Subject: **Palo Verde Nuclear Generating Station (PVNGS)**
Units 1, 2, and 3
Docket Nos. STN 50-528, 59-529, and 50-530
License Amendment Request to Revise Technical Specifications
to Adopt TSTF-505-A, Revision 1, Risk-Informed Completion
Times

**Description and Assessment of Proposed Amendment for Risk-
Informed Completion Times**

Insert for page 3.5.3-1

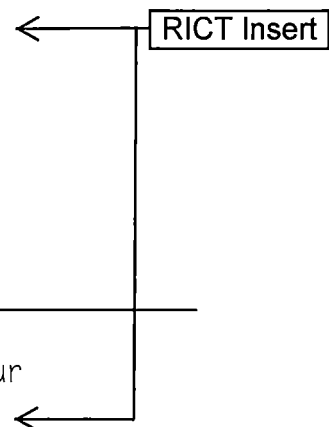
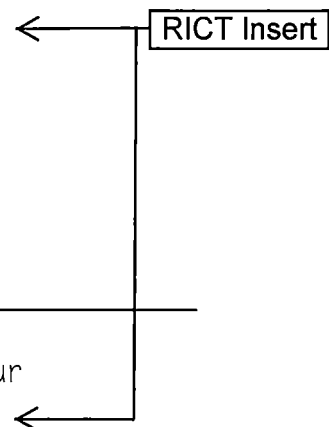
<p>C. ----- NOTE -----</p> <p>Not applicable when second ECCS train intentionally made inoperable. -----</p> <p>Less than 100% of the ECCS flow equivalent to a single OPERABLE train available.</p>	<p>C.1 Restore ECCS flow equivalent to 100% of a single OPERABLE train.</p>	<p>1 hour</p> <p><u>OR</u></p> <p>In accordance with the Risk Informed Completion Time Program</p>
--	---	--
